Doc. No.: CS-4540-001A-2-TECH-AMDT. 01 EPC Package for Talcher Thermal Power Project, Stage-III (2x660 MW) Amendment No. 01 to Technical Specifications Section-VI

Doc. No.: CS-4540-001A-2-TECH-AMDT. 01 EPC Package for Talcher Thermal Power Project, Amendment Stage-III (2x660 MW) Specification

TALCHER THERMAL PO ER PRO ECT

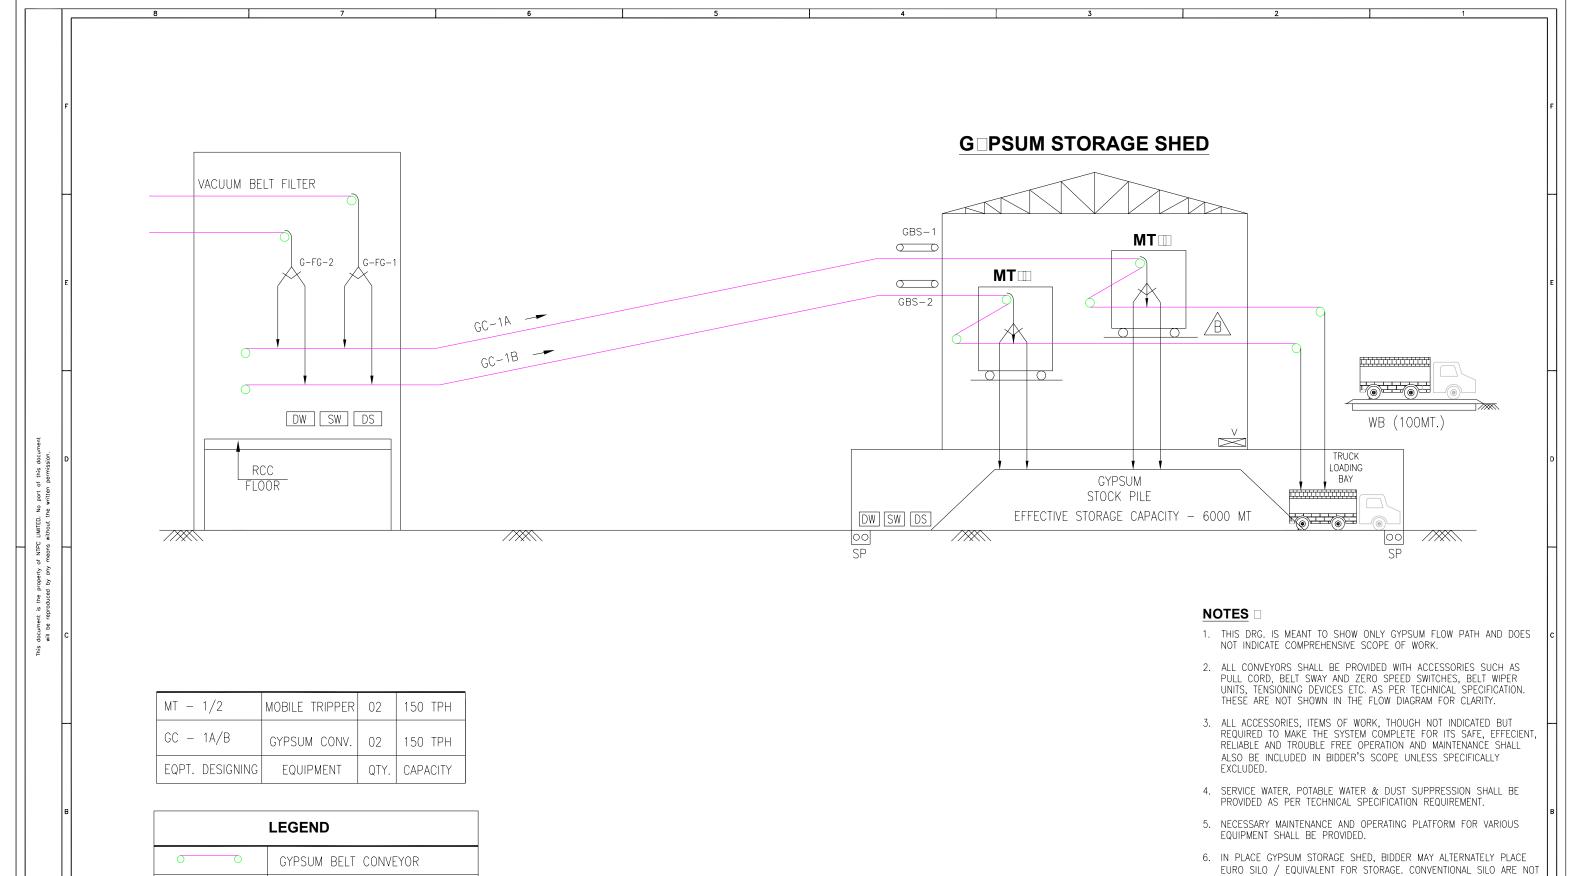
REVISED AS PER BIDDER'S QUERIES

TYPICAL CROSS SECTION OF DOUBLE LANE SURROUNDING MAIN POWER HOUSE

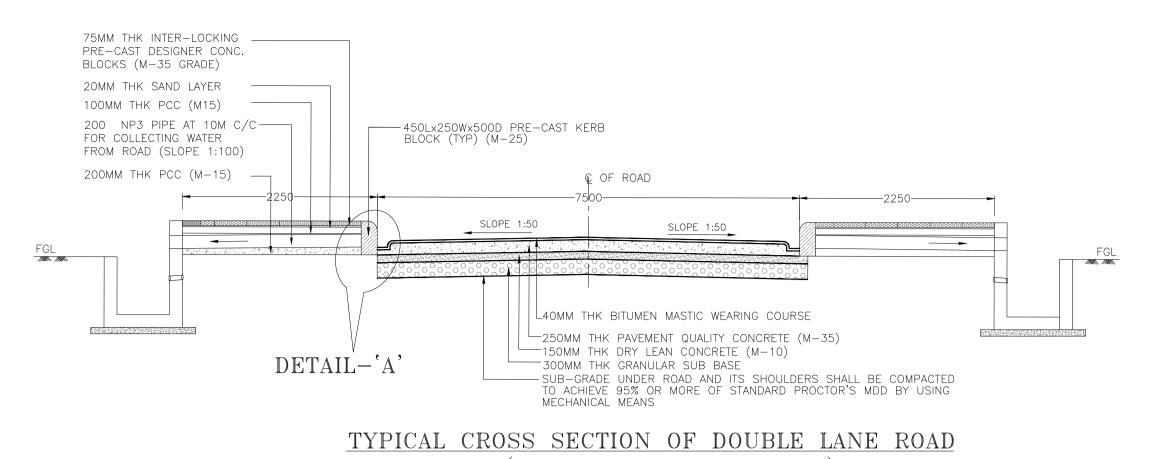
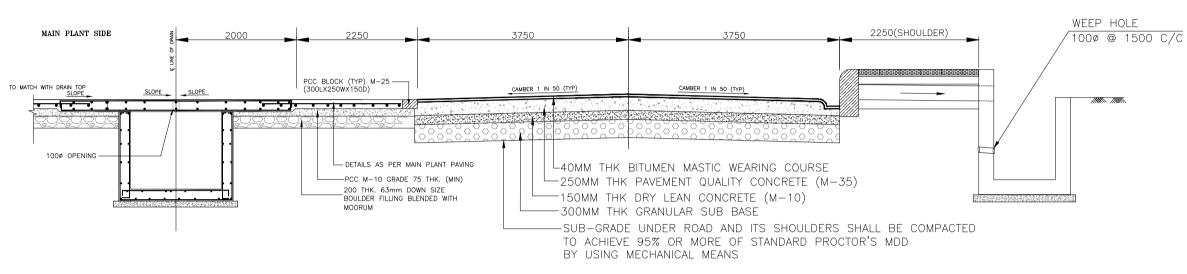
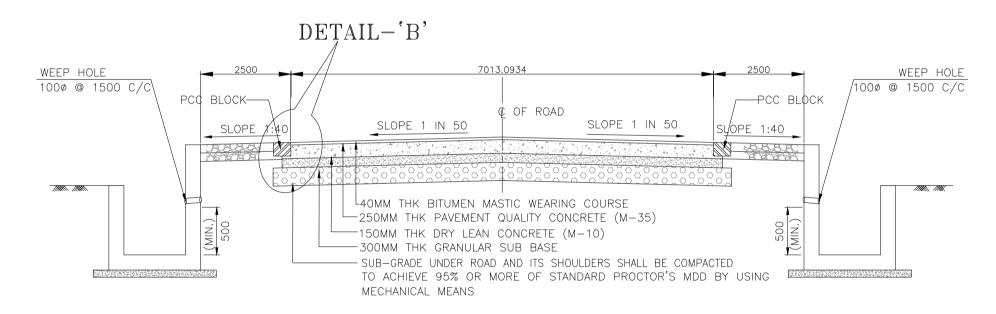
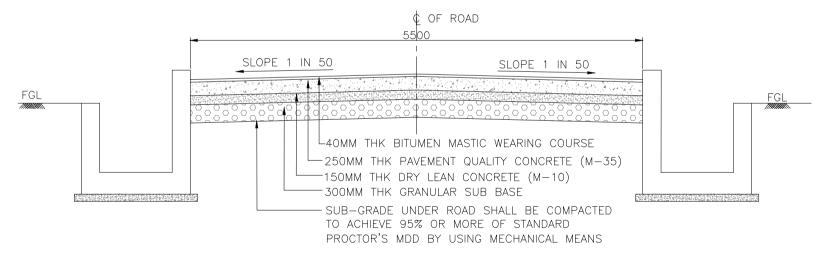
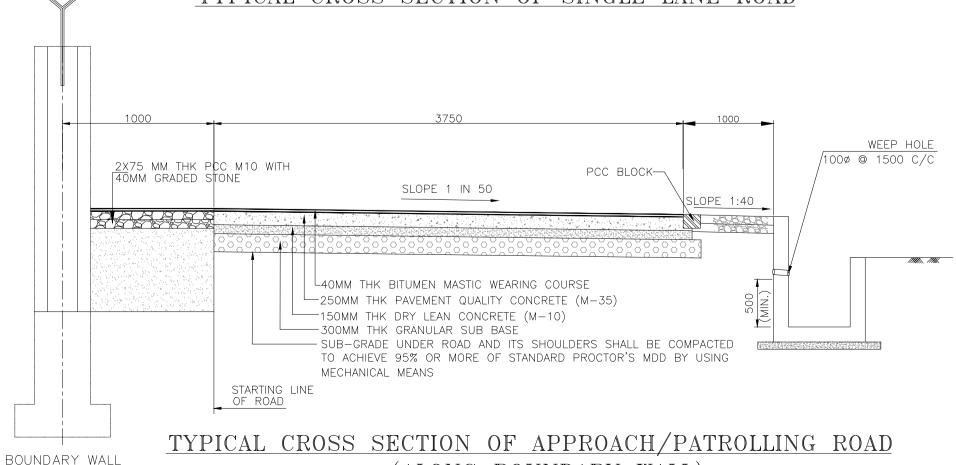
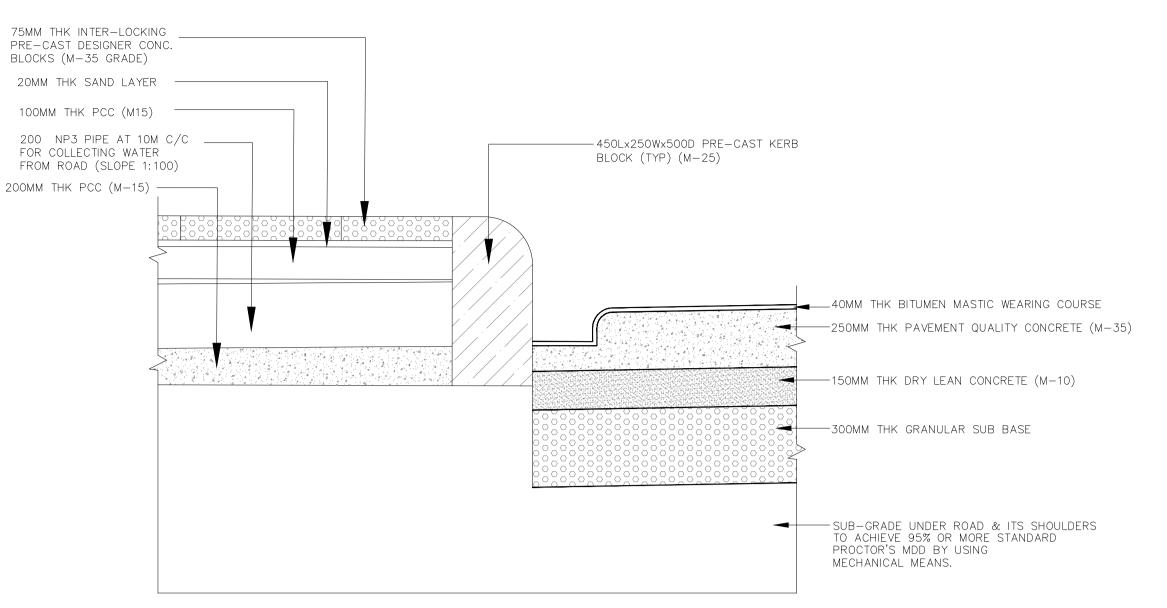
THICKNESS OF PQC CHANGE AS PER TECHNICAL SPECIFICATION MANOJ KK O FOR TENDER PURPOSE ONLY MANOJ KK - CS 30.11.2 DRN DESIGN CHKD. C C&I ES DESCRIPTION CLEARED BY
